TrakBOOK TECH UPDATE

LO206 Rocker Arm Minimum Length on P/N 557015

From Briggs & Stratton Racing:

Trim Tab Close-up

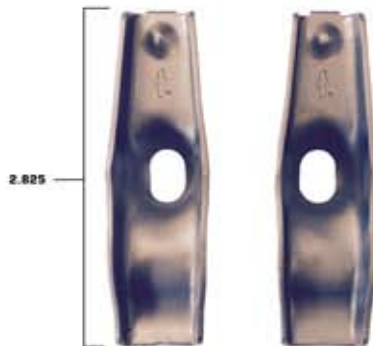
Machining advancements in our final trim die is resulting in the small tab highlighted in the image below being reduced. This does not impact performance or require any attention by our racers. The new minimum simply reflects the reduction of the tab as shown.

24F: Rocker Arm – overall length 2.825 inches minimum. Can be checked using a dial caliper.
